SCHWEIZER SERVICE INFORMATION NOTICE

NOTICE NO. N-181
DATE 9 APRIL 1982
PAGE 1 OF 12

SUBJECT: INSPECTION, REPLACEMENT AND NEW TORQUE REQUIREMENT -
PN 269A5104 MAIN TRANSMISSION RING GEAR, PN 269A5194
RING GEAR CARRIER ASSEMBLY AND ATTACH HARDWARE

Figure 1. Ring gear carrier - maximum acceptable wear

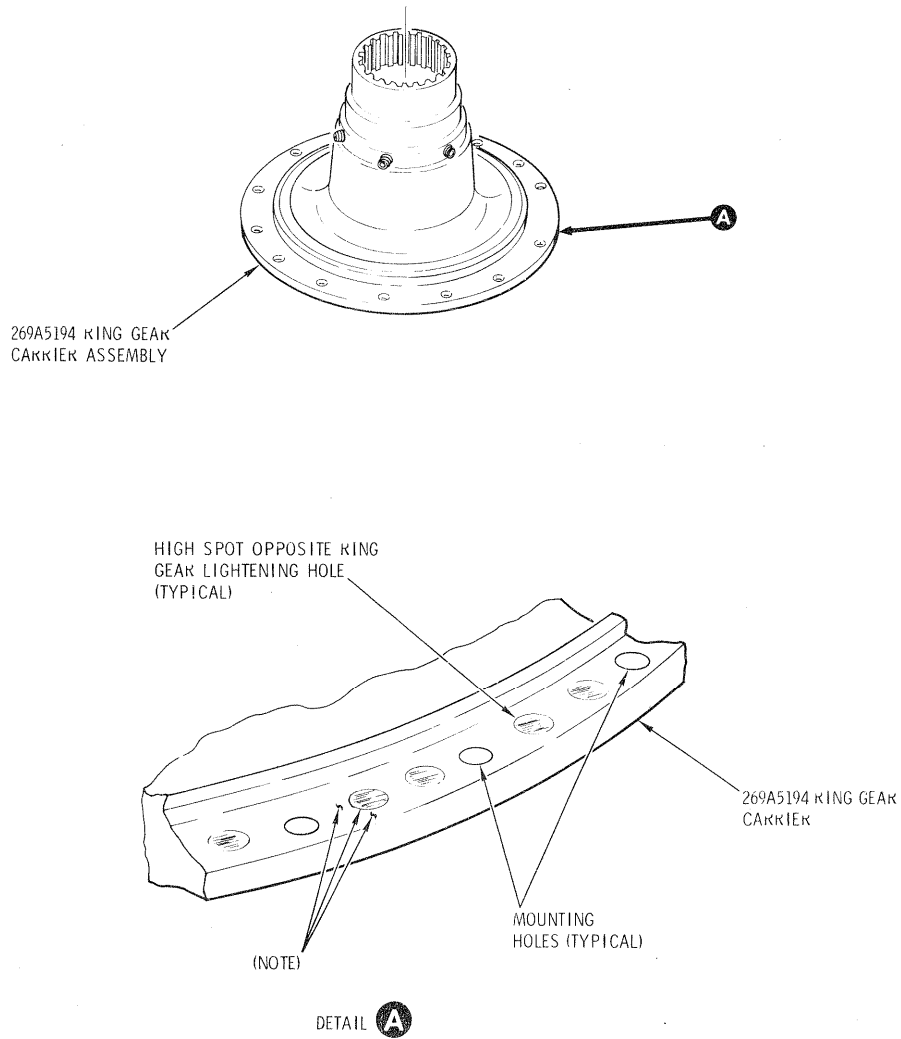
To establish maximum acceptable wear without machining, if no fretting, cracking or pitting exists, run dial indicator over high spots opposite lightening holes in carrier mounting surface as shown in Figure 1. A maximum of 0.002 inch differential is acceptable.

NOTE:
RUN DIAL INDICATOR OVER HIGH SPOTS AND ADJACENT AREAS. MAXIMUM DIFFERENTIAL OF 0.002 INCH IS ACCEPTABLE.

Figure 2. Ring gear carrier - machining to remove cracks, fretting, wear

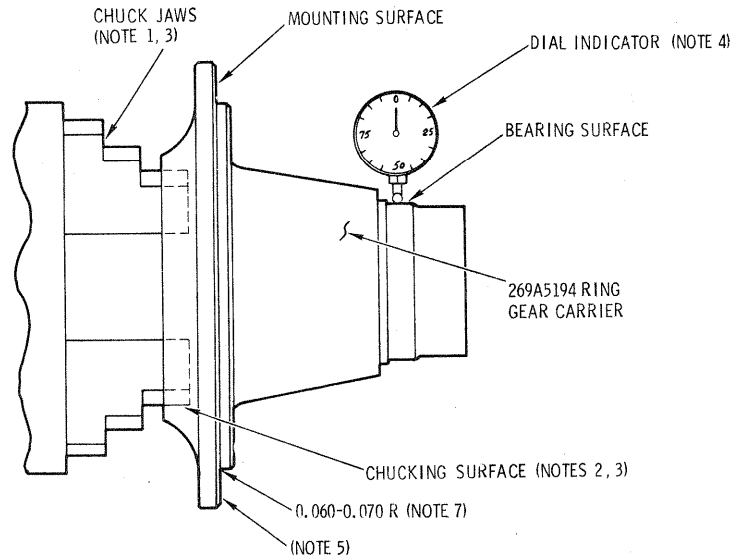
1. Remove fretting, pitting or cracking on carrier by machine boring as shown in Figure 2. Use dial indicator to true piece and upper bearing journal to 0.0005 inch or less. Maximum material removal from mounting surface is 0.015 inch depth.

1. CHUCK JAWS SHALL BE SOFT (ALUMINUM) AND DRESSED TO ENSURE CONCENTRICITY.
2. CHUCKING SURFACE IS LOWER BEARING JOURNAL.
3. CLEAN JOURNAL AND CHUCK TO PREVENT CLAMP UP ON ANY BONDING AGENT.
4. USE DIAL INDICATOR AND TRUE CARRIER AT UPPER BEARING JOURNAL TO 0.0005 INCH TIR OR LESS.
5. MAXIMUM STOCK REMOVAL FROM MOUNTING SURFACE IS 0.015 INCH DEPTH.
6. CHECK TIR PERIODICALLY DURING MACHINING.
7. BLEND RADIUS AT ROOT OF MOUNTING SURFACE WITH INDIA STONE OR EMERY CLOTH.

Figure 3. Ring gear carrier crack removal criteria

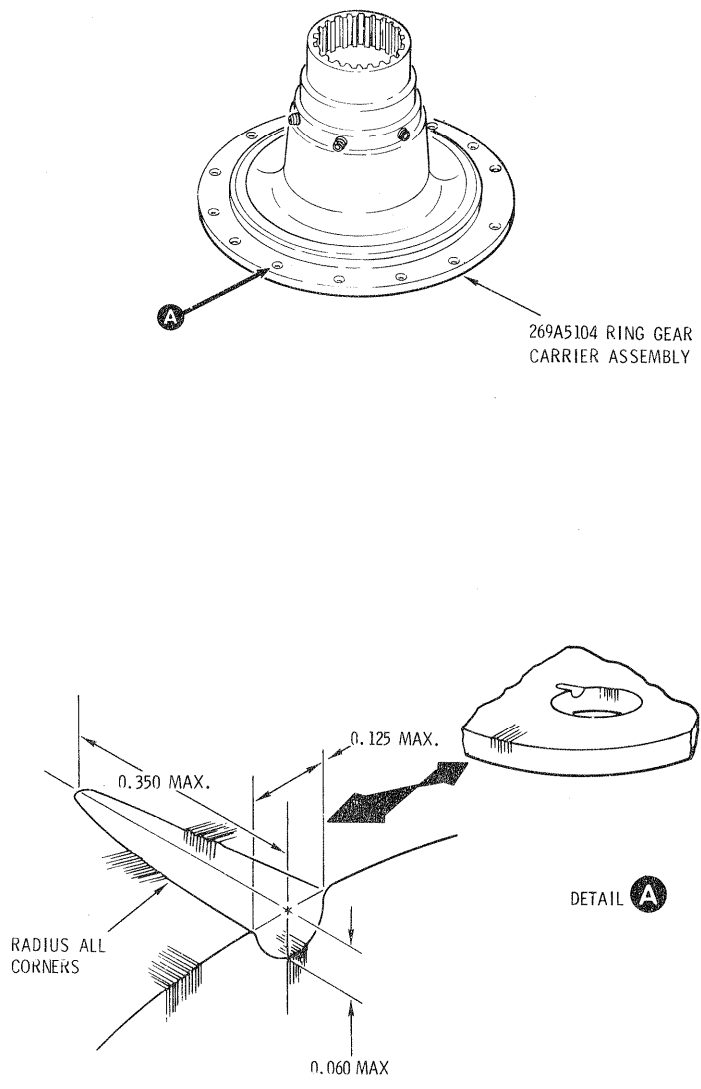
2. Cracking less than 0.060 inch depth and 0.350 inch length may be stoned or ground out after machining. Maximum width at any point of crack removal shall not exceed 0.125 inch, nor more than 0.350 inch in length, nor 0.060 inch in depth. All corners resulting from crack removal shall be radiused to remove sharp edges. (See Figure 3.)

Figure 4. Checking mounting surface to upper bearing alignment

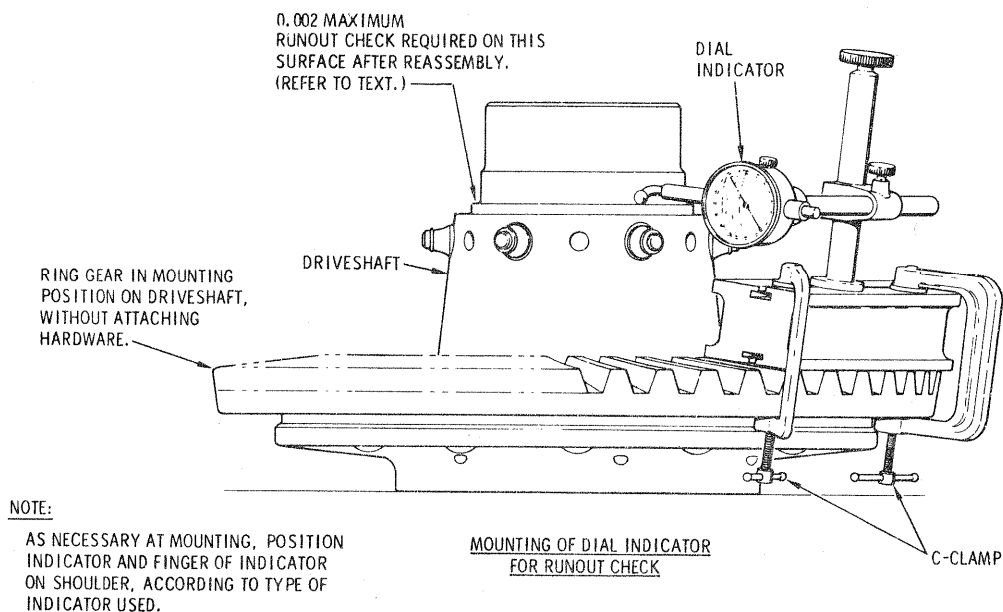
i. Before assembling ring gear and carrier, place ring gear on carrier without attach bolts (see Figure 4) to determine perpendicularity of ring gear to upper bearing surface. Mount dial indicator on ring gear and rotate gear with indicator resting on upper bearing journal as shown. Maximum runout shall not exceed 0.002 TIR.

Figure 5. Inspection and replacement - ring gear, ring gear carrier, attach hardware

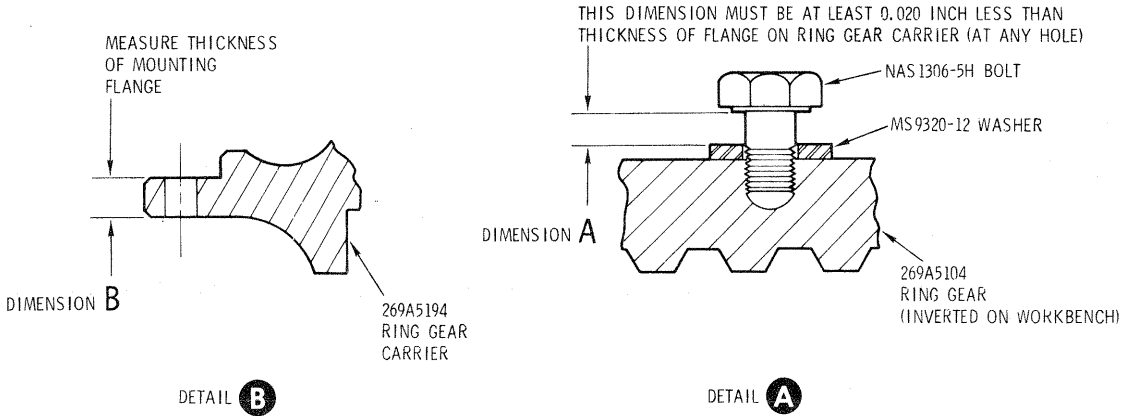
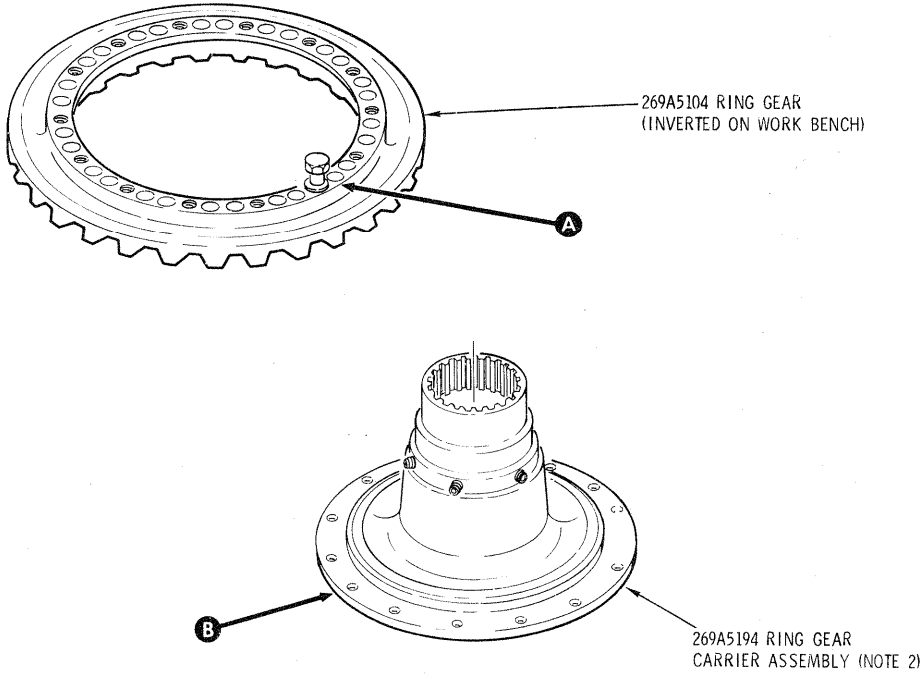
Before reassembly, invert ring gear on work bench and install NAS1306-5H bolts (with MS9320-12 washer) fingertight in ring gear (see Figure 5). Measure distance between washer and bolt head as shown and label Dimension A. Also measure thickness of ring gear carrier mounting flange and label Dimension B. Dimension A must be at least 0.020 inch less than Dimension B to preclude bolt bottoming out in ring gear. Install shorter NAS1306-4H bolt at any hole where Dimension A is not less than Dimension B by 0.020 inch or more.

k. Reassemble ring gear and carrier assemblies per HMI Appendix C, except as follows: Install new MS9320-12 flat washer under bolt head (14 places) and dry torque ring gear bolts to 365 to 390 inch-pounds torque. Lockwire bolts in sets of two.
